SUBJECT: CANTERWOOD (TTM No. 37439) TRAFFIC IMPACT ANALYSIS RESPONSE TO COMMENTS

The following Response to Comments letter has been prepared for the proposed Canterwood (TTM No. 37439) development ("Project"), which is located on the northeast corner of Leon Road and Craig Road in the County of Riverside, to address the comments prepared by the City of Menifee, dated March 23, 2020. The City on Menifee comments are provided in Attachment A of this letter.

ATTACHMENT A
CITY OF MENIFEE COMMENTS, MARCH 23, 2020

EXHIBIT 7-7: EAPC (PHASE 2 PROJECT BUILDOUT 2025) SUMMARY OF LOS

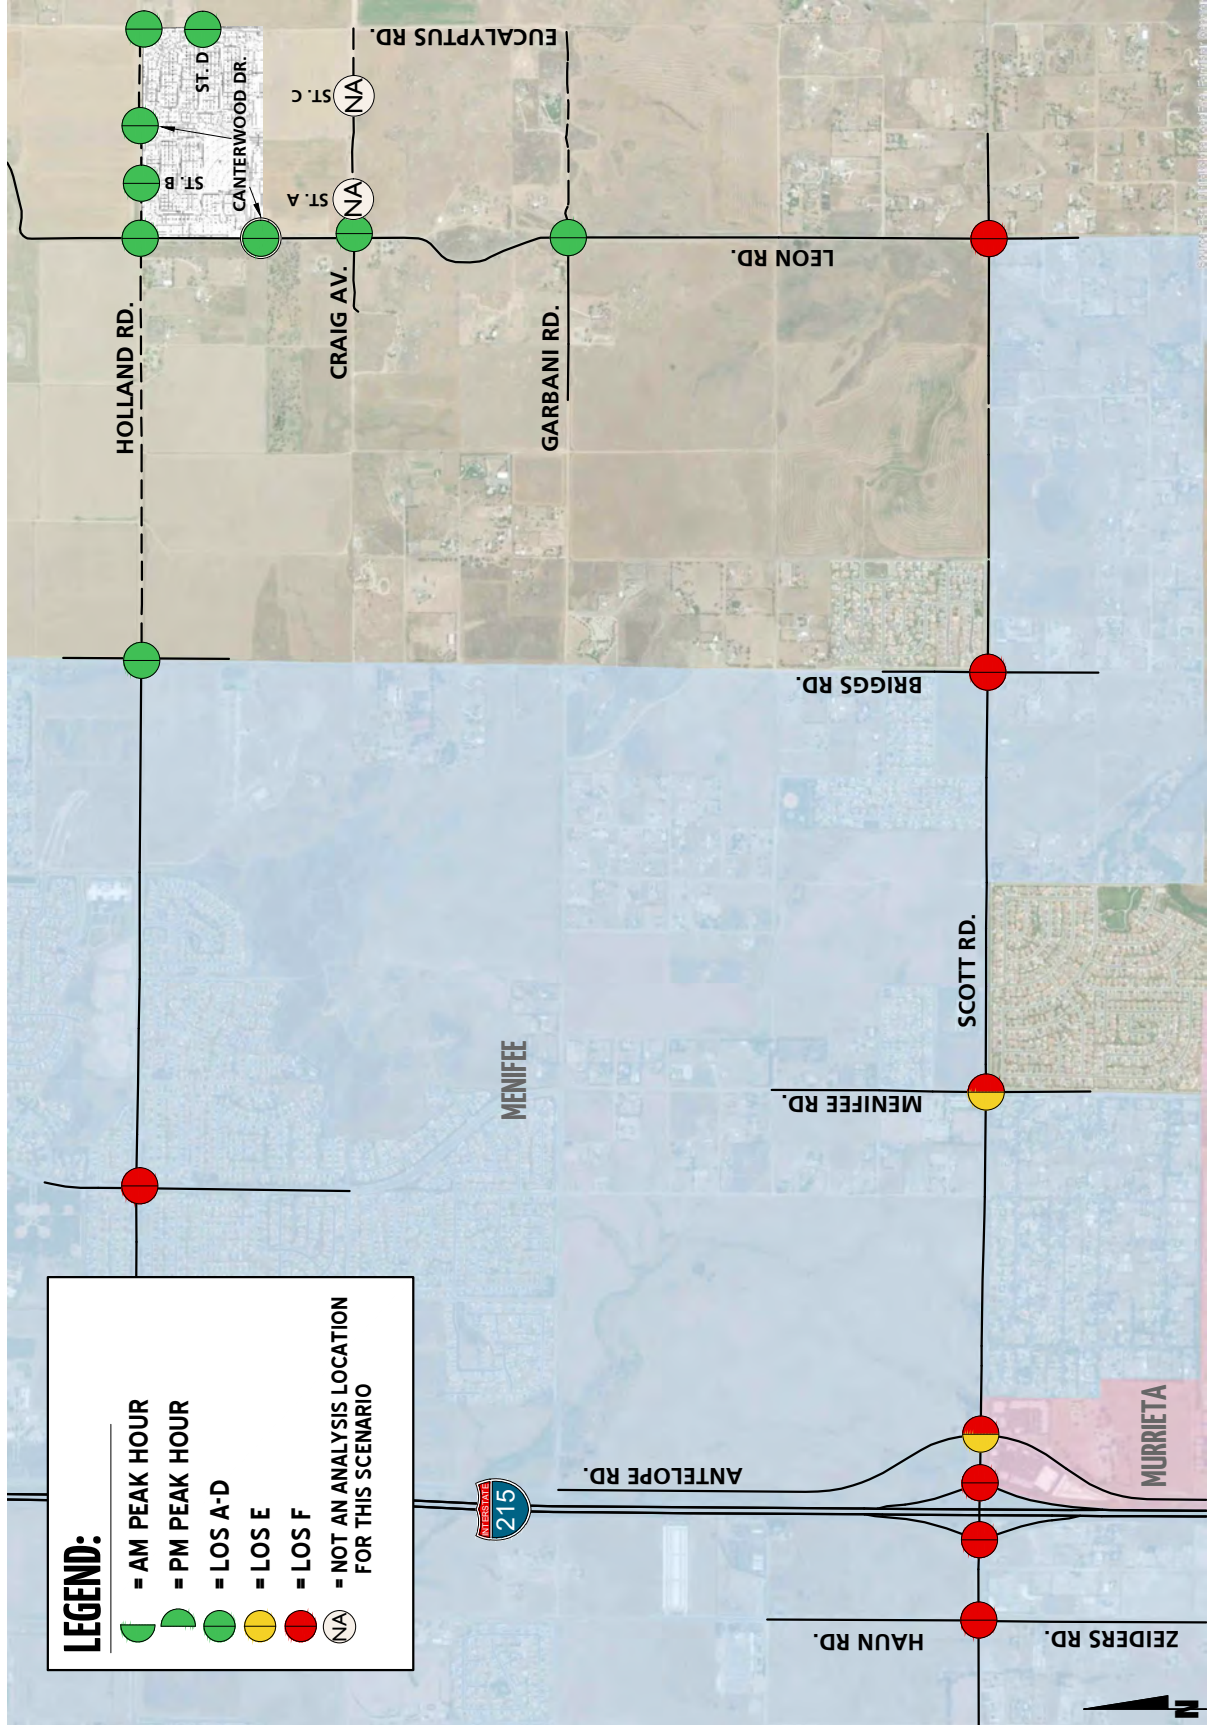
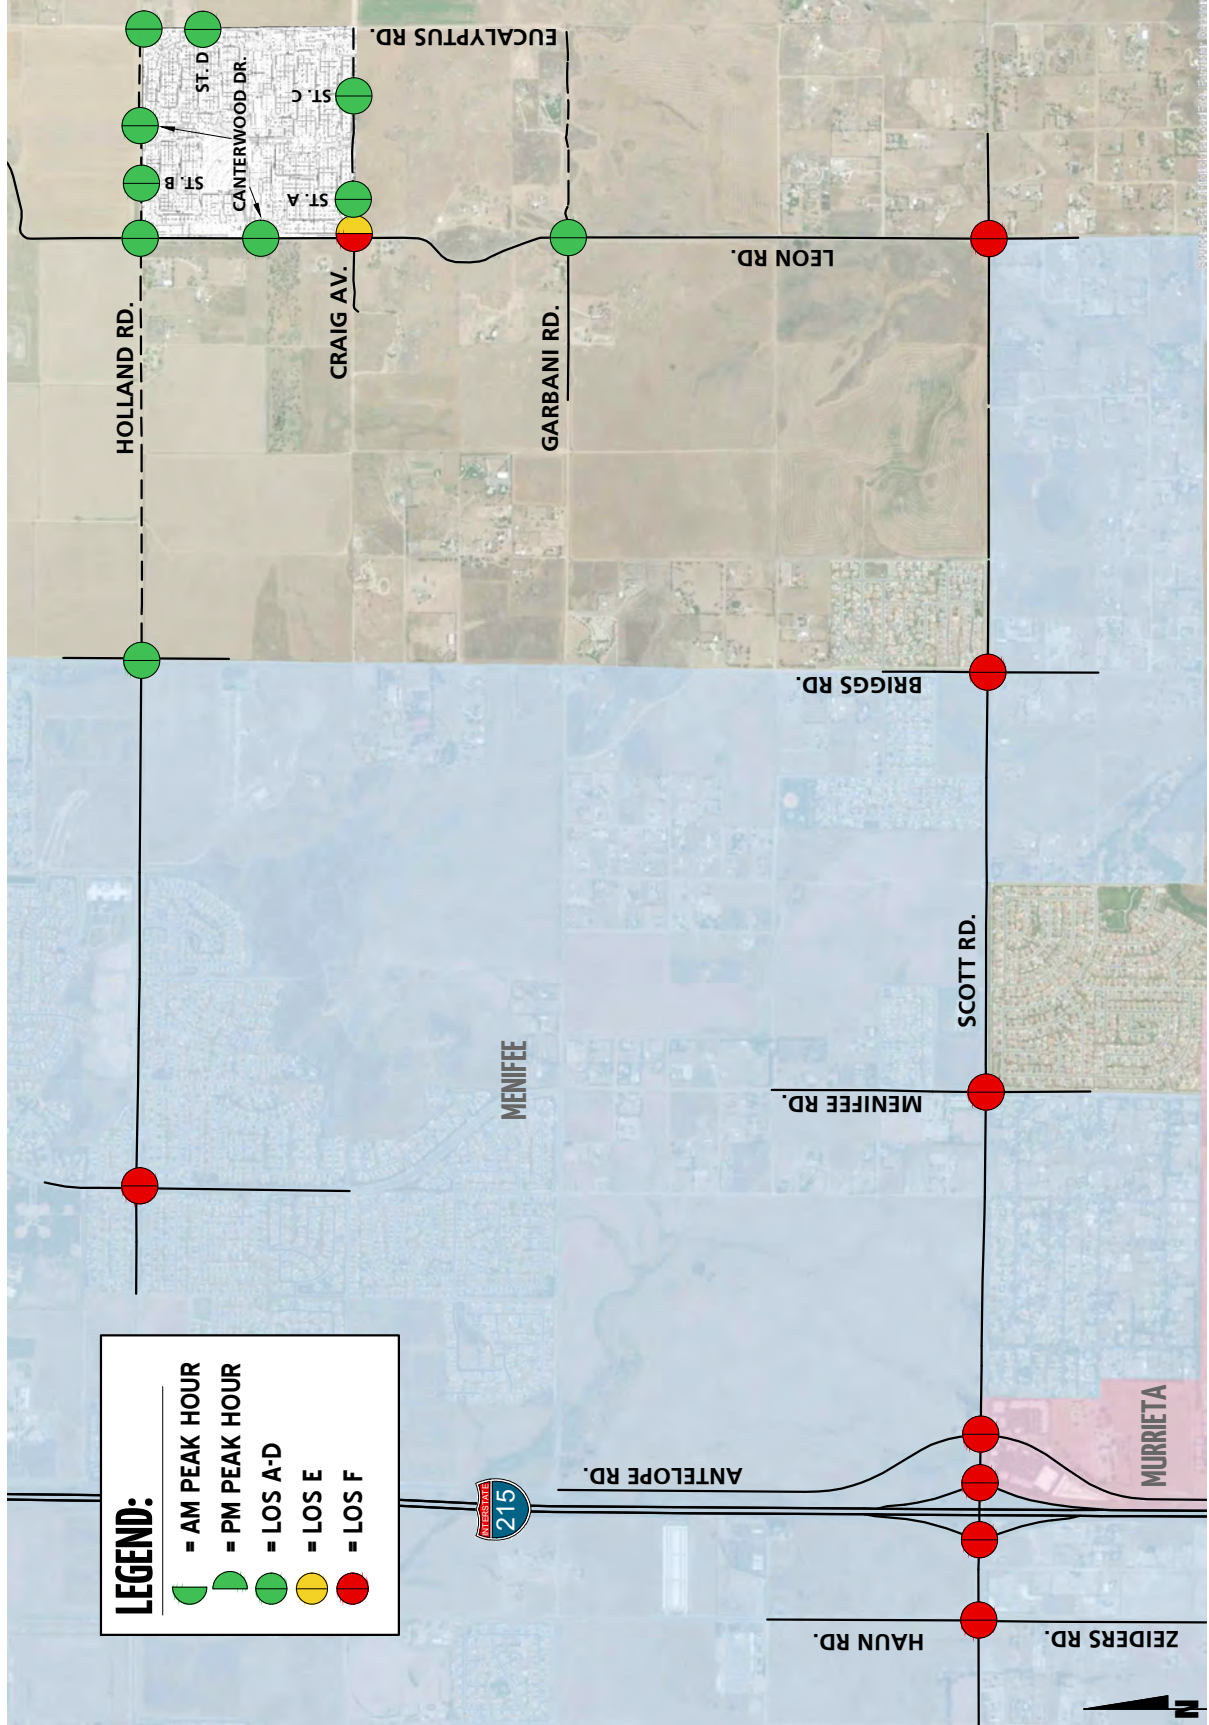
4. Summary of LOS Exhibit (all scenarios): On some of the exhibits for some intersections, the condition shown on the exhibit is not consistent with what is reported in the intersection conditions table. For example, on Exhibit 6-6 for Scott Rd/Leon Rd, the PM condition is shown as green, but should be red. Please check all the exhibits to match the intersection conditions table.

All summary of LOS exhibits has been reviewed and updated to be consistent with the intersection LOS tables. The typo occurs on the LOS summary of exhibits only. However, the intersection improvement recommendations are based on the intersection analysis tables not the exhibits, therefore no findings would change in the Traffic Study. The corrections to the affected summary of LOS exhibits are attached to this response to comments letter.
